Contents

American National Standards

BSR/ASHRAE/NEMA Standard 201-201x, Facility Smart Grid Information Model (new standard)

The second public review draft of proposed BSR/ASHRAE/NEMA Standard 201P contains a number of independent substantive changes to the first public review draft that constitute the scope of the review. The clauses containing these changes are enumerated below. Each change is described and then presented with some surrounding context to aid the reader in understanding where the change occurs. The specific changes are highlighted with strike through (deletions) or underline (additions). In the case of diagrams, the changed portion is highlighted with an oval.

Figure 6.4 - Measurement Sets

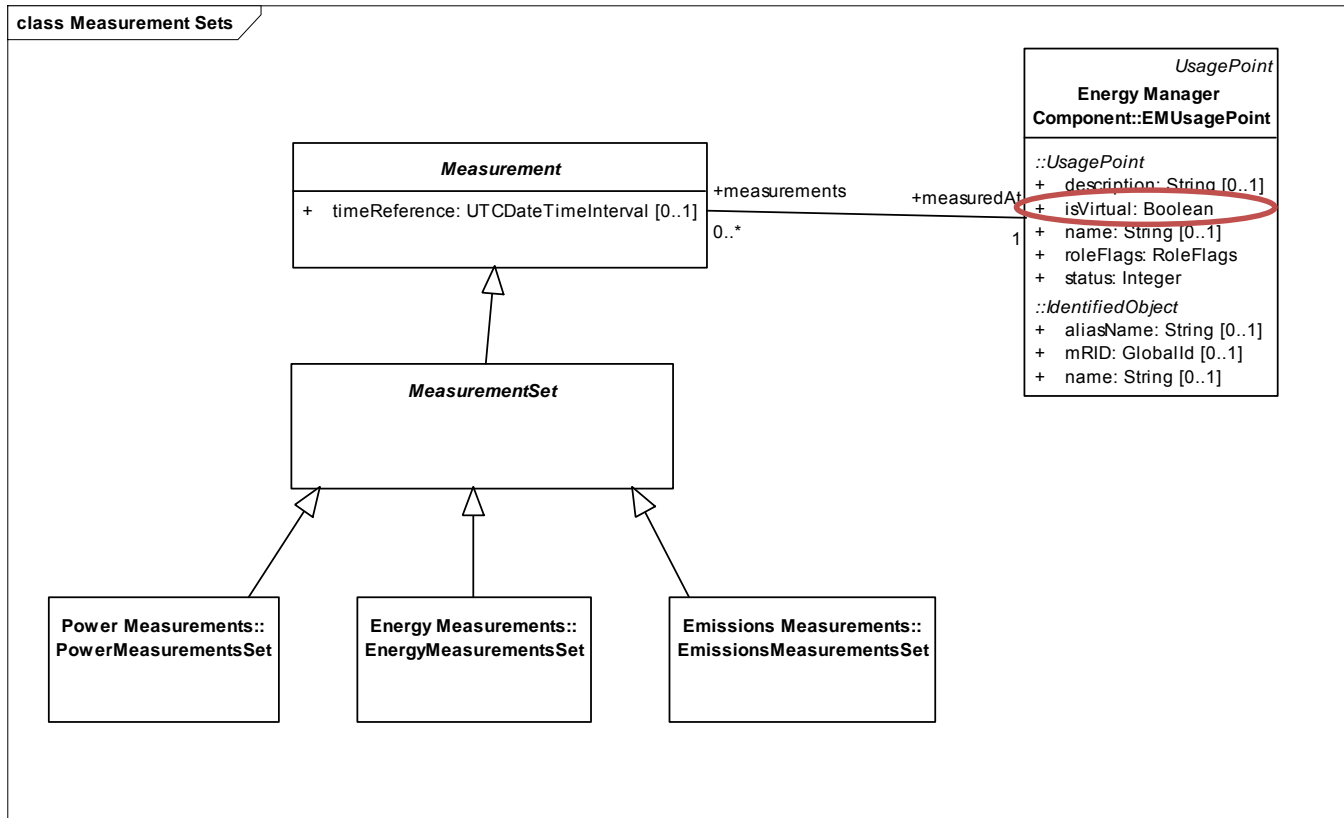
Background: A new attribute, isVirtual, was added to the UsagePoint class. This attribute appeared in a revision of IEC 61968-9 and serves as a flag to indicate a virtual measurement. This same flag was added to Green Button and will be added to the next release of "NAESB Business Practices and Information Models to Support Priority Action Plan 10 - Standardized Energy Usage Information standards. Revision 1.1 2012.

Because EMUsagePoint is derived from UsagePoint, the change affects Clause 6.4.2 Measurement Sets (Figure 6.4) and the EMUsagePoint Conformance Block (Figure 7.24).
